## Share Your Thoughts on the Proposed Draft Design Concepts for the New Park at South Eads Street and Army Navy Drive

(201 Submissions)

Please answer the following questions for CONCEPT 1- THE MEANDER

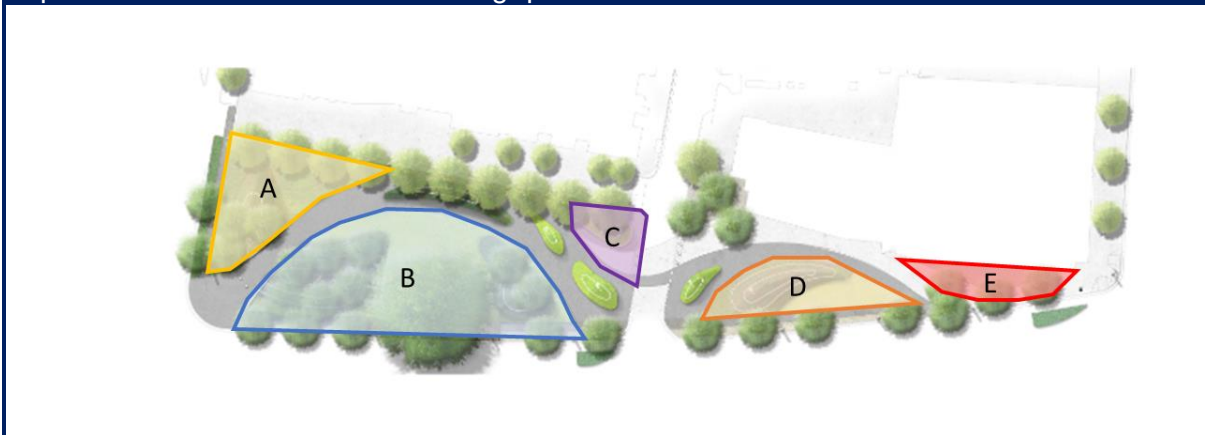
**What aspects of Concept 1 do you think could be better?**

None
Bridge over 11th street
Limit width of meandering path to 8 feet or less. Eliminate lawn in Zone B. Minimize impermeable surfaces. Eliminate Zone E.
keep dog presence to a minimum; PenPlace across the street is supposed to have a dog park
The synthetic berms need to go away. A more natural ivy or plant should be used instead
eliminate a lot of the concrete
more land and trees
Create fewer places for homeless to gather
Designated dog space
More walkway
Suggest a designated area for dogs so lawn areas B, D are not used for dog stool.
no dog park
Dog run/park

<p>i like the 11th street crossing that ties that area to the park more than road-safer for pedestrians</p>
<p>Less use of berms, which are questionable if intended for seating. This design splits up the walkway at the cost of open space.</p>
<p>Add a moving water feature, using berms and gravity for a small, naturally flowing stream. Combine with stormwater vault.</p>
<p>Water feature</p>
<p>Need some color, Pentagon City is a vibrant if random place, we love that and would love the park to reflect that personality.</p>
<p>STILL TOO MUCH HARDSAPE/PAVEMENT, WHERE NOW THERE IS LITTLE OR NONE. REDUCE THE HARDSAPE, INCREASE PERVIOUS/NATURAL SPACE.</p>
<p>I think it's too small a space to be a meander, plus Met Park nearby will have that concept. Better more direct</p>
<p>Too much space that looks like it would just be used by dogs for restroom activities</p>
<p>More grass open areas</p>
<p>The meadow sounds pretty to look at but we really, really need a place to toss a ball, lay in the grass on a blanket in the sun.</p>

<p>Too meandering, needs more direct alternative route/cut through</p>
<p>Make sure there is comfortable seating- I fear that dog uses would make the grass unsuitable for sitting</p>
<p>N/A</p>
<p>more seating</p>
<p>Too much space for people</p>
<p>No dog park</p>

Less paved, wide road. More natural, narrow road.
Reduce amount of Hardscape
too noisy
There is not a lot of seating, it's seems like it's designed to be passed through. I use parks to relax w friends
too busy noisy
Needs direct access to Altaire via front door. Otherwise patrons will just cut through the trees. Make it easy for them
Dog areas
More multi use
I think it's hard with lawns and the number of pets in the area to keep them from becoming dogs' bathrooms.
Seating
I do not like the high concrete berms at the entrance from Army Navy drive.
More meander
A,C
Dog run, fitness equipment
too many paths/trails
E
Less concrete and an enclosed dog area
Specific area for pets
Path looks a bit narrow, social area is small

Don't like it
Concept 2 better
add water (fountain, pond, reflecting pool)
e
It seems to not link with the community - it is not uniting
no synthetic turf
A
not sure
more flowering plants
I like it as is.
More space for pets
Too many trees. Not enough open space for dogs
C
Informal meeting place
no comment for this design
C
Maybe some seating?
Would like to see small seating amongst the trees
N/A
C

Is there a more direct pedestrian route?
Not requiring bikers to dismount
most dangerous crossing of 11th (meanders, poorest sight lines); no bike access; no dog facilities, plaza too small to be useful
Could be a few nook Seating spots/zones
While it seems like a serene space, I would like the option of a gathering space, I like the idea of having a farmers market
Fewer berms and paved stretches
The high concrete berms look cold and corporate. Like an office park that you're not meant to hang out in.
Provide more seating space
attractive shrubs and plants - see Boston Greenway for ideas
I do not understand the large berm in section D. It feels like it dominates the space.
The areas are not clearly delineated and there isn't an area designated for dogs.
Adding some gardens would be nice
Not thrilled about the sloping entrance wall at the Eads/Army Navy corner. Why not a more classic looking vertical stone wall?

N/A
seating - add it all along the path, in nooks off the path, in hidden areas near the path
More small paths
Purposeless

<p>what's the draw besides lunch breaks to the park? It will be like all the Crystal Drive pocket parks w/out a draw or connection</p>
<p>d</p>
<p>Will the synthetic turf berms look out of place? That will need to be an important detail to execute if approved.</p>
<p>It feels like the berm in D occupies a lot of otherwise usable open space</p>
<p>less pavement</p>
<p>more seating</p>
<p>N/A</p>
<p>Main sidewalk along street makes it easy to bypass the park.</p>
<p>fixed seating so wind does not move furniture around</p>
<p>Might be focused a bit too much on the path.</p>
<p>less concrete bulk along path - incorporate native stone instead - use boulders in section D</p>
<p>e</p>
<p>Add seating</p>
<p>People design 'meanders' and then anyone trying to get someone is driven crazy by the ... meander.</p>
<p>It treats 11th Street and the adjacent Eads St bike lane as external elements. They both need to be integrated into the design.</p>

<p>Space marked B should be a pump track</p>
<p>Add bicycle infrastructure like a small bicycle pump track for youth</p>
<p>Bike area for kids. I'm not loving the idea of pet facilities. Also, there seems to be a lot of hard surfaces.</p>

Please answer the following questions for CONCEPT 2- THE CANAL WALK

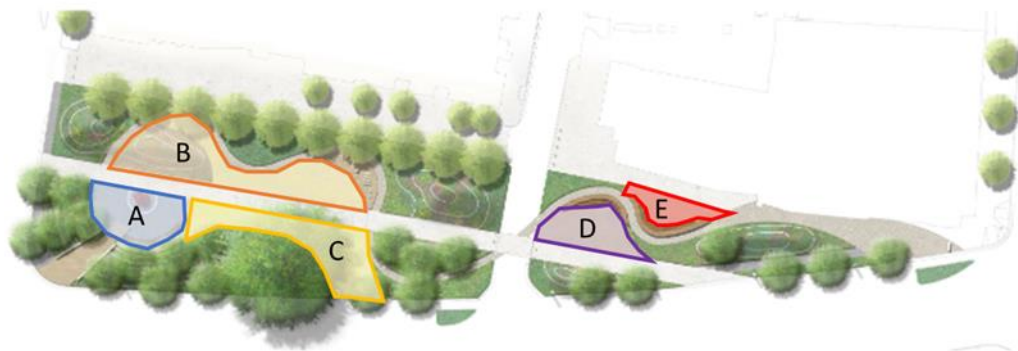
**What aspects of Concept 2 do you think could be better?**

Seating
Bad idea to mix bicycles with pedestrians and especially children or seniors. Where is the canal or a stream?
What is the difference of width between main trail and little trail? Would the little trail be too little?
Remove the central straight walkway/bike path. Remove Zones D & E. Reduce pavement and hardscape, especially at south end.

plaza for social gatherings not needed or wanted
More seating options
dog space
Create fewer places for homeless to hide and gather.
The addition of seating is dangerous for the area. It will attract the homeless and lead to crowds at our building.
Designated space for dogs
Multipurpose path, bicyclist should not be allowed thru the park. There are plenty of bicycle facilities in surrounding area.
outdoor fitness
Dog run/park
the straight path feels like bikers may go full speed and disturb others
There is still too much emphasis on berms, especially as you move south through the park.
Even a main path can have a slight curve to it, which is a more natural way to raise awareness of shared use and other users.
way too much pavement
Nicer flow
Hate the idea of bikes going down the middle. They don't need a park for that, such a waste and splits the park even further.
WAY TOO MUCH HARDSCAPE/PAVEMENT. REDUCE THE PERCENTAGE OF HARDSCAP/PAVEMENT AND INCREASE GREEN SPACE.

No gathering space
More shade trees

More open grass areas
The cycle path chops the park in half. People coming from the Pentagon aren't going to want to meander on the walk
Needs separate area for dogs
Don't think bikes need to be passing through the park, it isn't big enough so bikes should use the surrounding streets
More grass space
Remove all seating and gathering areas.
No fenced dog area
Less chance for any speeding on the middle, straight road
move the straight walk to the Apartment side instead of breaking up A,B & C for cyclists
All
bike path is too straight; curve it some to help decrease speeds on that path. Locate it at the edge of the park, next to stree
have the water feature meander a bit, not be so straight
too noisy
A - I think the plaza should be more Concept 3
I think it's best to keep the bikes on the road, not going through the middle of the park.
Access to Altaire front door.
Straight path will be used by bicyclists and disruptive

no larger open space, too many trees on edges cutting into the actual space

Is it trying to cram too much in? Attention to how to keep lawns from being dog spots only.
Outdoor fitness
understand the canal concept but straight line walk will turn into a biker raceway
It should not be used as a pass through for bikes. Central walkway cuts up a small space
this is too small a park to "get lost in" so I prefer concept 3 with specific uses
Smaller straight line path
path
A B C D E
dog run
E
Bikers should walk bikes or go around the park; straight Promenade seems to "city-like" rather than a quiet escape
None
Is this path just another street? What makes this a park vs a trail?
This is a bit boring, the meandering path is prettier
too chopped up; straight middle path encourages fast scooters, skateboards, cyclists (not relaxing walking, sitting, as refuge)
Get rid of straight path
An area for outdoor events and concerts perhaps
No straightaway esp. for bikes. Too much pavement, dangerous. Not enough quiet spaces. A/N Drive too loud for berm seating

tries to appeal to EVERYONE, which means that no one will be happy.
D
not sure
B
add art work or flowering plants
E - Platform Benches - Not sure how this seating will work, would like to understand it better.
West end of canal walk is not at a crosswalk
Area for slightly larger groups, events ( like farmers market)
Flow of pedestruan traffic between buildings and intersection.
Zones are set too close together for a quiet area
D
Straight walkway
zone E looks a bit dry compared to other areas of the park
no comment
Don't like bike path through the middle
More natural looking landscape, it's too straight, I fear it'll be used as a normal path rather than a park.
not a great use of space
Finding a larger contiguous open or natural space
can art be a fountain/water element? and add more green on the southern end? combining meander and straight crossing needs work

<p>Its one straight path which isnt as interesting.</p>
<p>There could be more usable space</p>
<p>Design looks like a paddle stick with a curved noodle stuck on for connectivity</p>
<p>Make the artwork plaza smaller so there is more permeable surface</p>
<p>The multi-purpose path running down the middle of the parks, eliminates otherwise functional space.</p>
<p>the park feels like separate areas and not a cohesive whole</p>
<p>Needs more trees</p>
<p>The central walk does not depict a canal. Unless there is water, the allusion to the canal is not useful. DC has a Canal Park.</p>
<p>N/A</p>
<p>The straight path could be more curvy to make walking through the park more fun</p>
<p>plaza for retail congregation perhaps; keep the main artery natural (dirt/garden) path to slow the traffic; shade variety</p>
<p>path</p>
<p>Is the berm in the lower parcel too dominating? It is difficult to understand scale at this stage of design.</p>

<p>The artwork and direct path occupy too much space....it really reduces the functional space of C and B</p>
<p>center path totally splits the park in half, creating wasted space. will just be a cut-through and not an active space.</p>
<p>outdoor fitness</p>
<p>I'm not fond of the very straight path.</p>

too much pavement and turf, no plaza or gazebo - too hot in summer
I am very pleased with Concept 2
No bike path. This is a bike friendly area with excellent pike paths. The park should be for pedestrians not bikers.
It treats 11th Street and the adjacent Eads St bike lane as external elements. They both need to be integrated into the design.
A, B & could be a pump track with bridges to go over the path
incorporate youth activity area for a bike park
Addition of bike areas for youth. The feel of the park. It feels too much like "lunch at an office building" for me.
maybe programming opportunities? Like/don't like the straight walk; see how people trample when meanders used
Add native flowers
More than one centerpiece significant tree
there should be an enclosed space for dog walking
None

Please answer the following questions for CONCEPT 3- THE CENTRAL HUB  
 Please refer to the following graphic as it relates to Concept 3 and this portion of the video or presentation to answer the following questions.

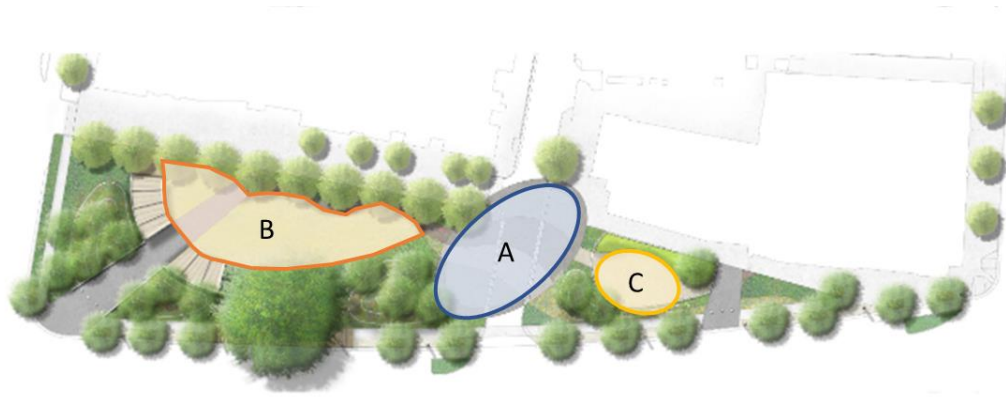
**What aspects of Concept 3 do you think could be better?**

Removal of playground or exercise area and dog run
Remove the large open areas. Bad in summer and certainly not good for social distancing.
Remove nearly all of the hardscape, pavement and mowed grass. This is the worst of all of the three concepts.
don't make this casual use park a social gathering place
I don't like the concrete plaza section
eliminate the shade structure it is a high maintenance and kind of unattractive
Create fewer places for homeless to gather.
I do not like seating and gathering spaces. Homeless people will simply use them and then attract them to where I live.
No need for Shade Structure, point of park is to be out in the sun. Not sure how useful plaza would be with cars driving thru.
social gathering space
Bigger dog run
feels more programming focused than individual use focused
Built-in seating at the south end could be used for both lunch from adjacent retail space and watching the dog run.

way too much pavement
Can do without the dog park. Last feature needed is dog park. This area smells like dog piss
Connection to retails shops.
Its small to have big areas for events or a dog run (though needed in this area), if we can't do it well don't do it.
WAY TOO MUCH PAVEMENT/HARDSCAPE. REDUCE PAVED/HARDENED SURFACES, INCREASE PERVIOUS GREEN SPACE. NOTHING CAN LIVE IN HARDSCAPE.
Given the nearby buildings, shade is unlikely needed. We do not need a dog run here, so close to the one at Met Park
B looks like it will be used as a dog restroom.
Less dog runs...they are not respected by patrons and look ugly and unmaintained
I'd narrow the walkway at the corner of Eads & Army Navy for even more buffering and that wow factor when you get into the park.
No dog enclosure- dogs will use the park, but shouldn't attract them when there are other larger parks nearby
I don't particularly like the oval shape of the plaza.

Too much space for people and pets.
More distinguished spaces and their functions
Way too much hardscape, when there are several other nearby parks for event space.
Not enough natural habitat
B - it's very shared green space. Would be harder to find little nooks or trees for yourself / friends

<p>Not a fan of the dog play area (just look at the mud hole in the park by Amazon to see how nasty they can be)</p>
<p>waste of space.</p>
<p>Clear and easy access to Altaire front/main door.</p>
<p>space for kids, seating</p>
<p>Smaller dog run</p>
<p>least favorite option...too much activity for small park</p>
<p>This concept needs to avoid the sterility of some Crystal City greenspaces. Do not support the dog run</p>
<p>for remote work, will there be wifi?</p>
<p>Not sure what A is, with the road there.</p>
<p>more areas for a variety of activities and peace.</p>
<p>Zone A is too large. It needs more trees.</p>
<p>B, A,C</p>
<p>fitness equipment</p>
<p>not a lot of walking room</p>
<p>Doesn't seem like there is enough overall area to support a dog park.</p>
<p>C</p>
<p>Creation of one or two small private areas with vegetation</p>
<p>None</p>
<p>Prefer several small pockets of social areas to one crowded/noisy one unless there is a large movie screen or something</p>

A
Not enough green space.
very urban--looks like a pocket park between highway and highrises
all
reduce amt hardscape pathways
That it pulls people together!
a
not sure
A
would prefer a walking path
Market area is not large enough to reach critical mass necessary for a successful market
Flow from building to Intersection. There will be trampling of vegetation.
Add another zone & a little less trees
B
no dog area
really eliminates the relaxing area and a lot of the nature aspects. Last choice of the three.
With new dog runs being built at Metropolitan Park, I don't think it's worthwhile to lose space to a dog run in this one.
A
Don't like the Area A by the primary driveway for LCOR development. It will never be that ped friendly area envisioned to be.

Remove dog run
can't have plaza in the middle of 11th! this is the most dangerous of 3 crossings. bollards are bad idea for any plan
There isnt an interesting walking path like with the meander concept
a water feature (fountain) would be nice
Dog run seems unnecessary if Amazon park is also going to have one.
Less plaza space and no dog park
A doesn't appear to be functional space.
seating in the plaza area - perhaps along the outside.
The design needs more green space. It's going to be VERY hot in areas A,B, and C
not a lot of usable, open space
I am not sure if the A section will ever work as a meeting place, with 11th St. there.
Not sure about shade structure/maintenance
use other than area A for weekday markets (traffic conflict)
More small paths to walk on and enjoy the space
Should NOT be a workspace
a defined path through the park connecting the spaces; ensure the lunch/work/retail space is effective; lawn for recreation

I think the dog run space in C is too dominating for such a small parcel. Other uses are more appropriate.
"A" takes up WAY to much useable space

zone a is overly paved
movable furniture / windblown around
The lack of a sense of through movement.
too much pavement and turf, no shade over turf and plaza
a
Direct route for cyclists and pedestrians.
It treats 11th Street and the adjacent Eads St bike lane as external elements. They both need to be integrated into the design.
The space below the path should be a pump track
open up space for youth activities like a bike playground
features of other 2 concepts ;)
Incorporate native flowers
plaza
None
